FIELD SERVICE CAMPAIGN BULLETIN

Subject: **Field Service Campaign 17M2-REV**
GHG17 Heavy Duty Engine Platform Front Engine Lifter Bracket

Figure 1 – Front Lifter Bracket Part Identification

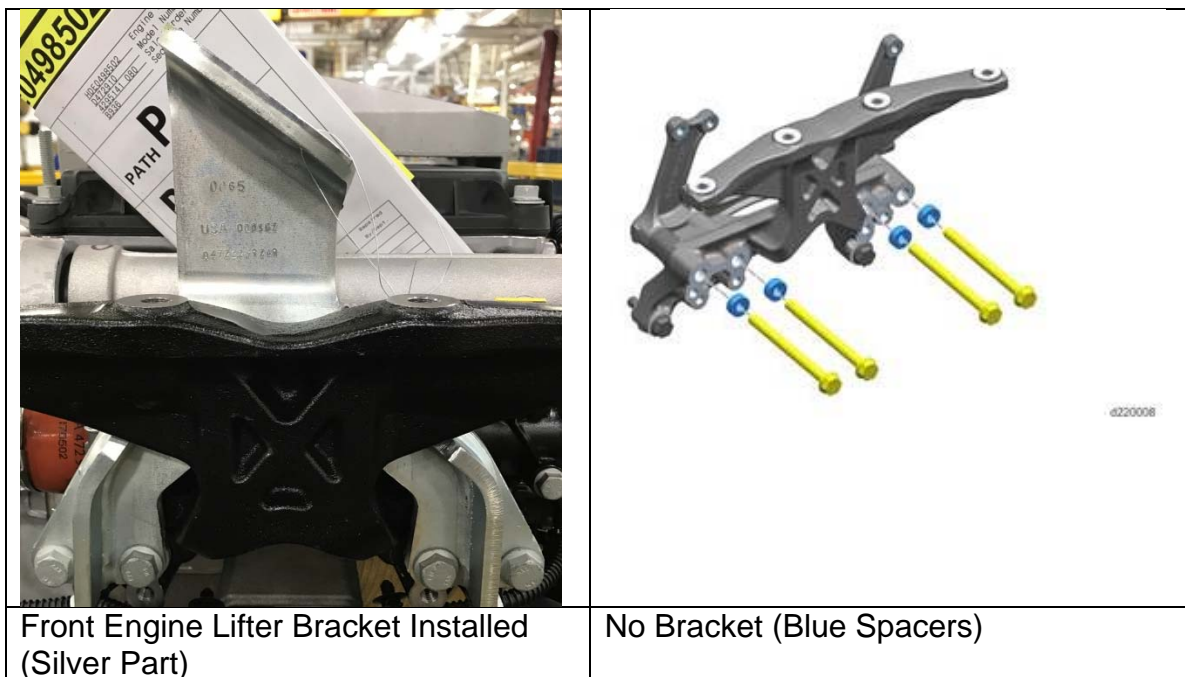
Detroit Diesel Corporation (DDC) has determined that some certified Model Year 2016 and 2017 GHG17 Heavy Duty Engine Platform engines will require the replacement or installation of a new front engine lifter bracket. These engines are installed exclusively in Freightliner® New Cascadia® vehicles.

The new front engine lifter bracket became effective with engines manufactured after approximately May 31, 2017. Any model year 2016 or 2017 engine manufactured between April 27, 2016, and May 31, 2017, installed in Freightliner® New Cascadia® vehicles, and having the previous lifter bracket or no lifter bracket, may need a new lifter bracket installed. Note that some trucks may already have been repaired and will be excluded from this program.

1. Apply the parking brake, chock the wheels, and perform any other applicable safety steps.
2. See Figure 1 for examples of an installed front engine lifter bracket or no bracket (spacers). Does the engine have a currently installed front engine lifter bracket?
 - a. If Yes, go to step 3.
 - b. If No, go to step 4.

The necessary part for this Field Service Campaign is lifter bracket P/N: A4722231241. Use only **ONE** bracket per vehicle.

4. Remove and discard either the old front engine lifter bracket or spacers. **REFERENCE** section “Removal of the Front Engine Lifting Bracket (New Cascadia)” in the *GHG17 Heavy Duty Workshop Manual* (DDC-SVC-MAN-0190).
5. Install the new front engine lifting bracket, P/N: A4722231241. **REFERENCE** section “Installation of the Front Engine Lifting Bracket (New Cascadia)” in the *GHG17 Heavy Duty Workshop Manual* (DDC-SVC-MAN-0190).
6. Repairs are complete.
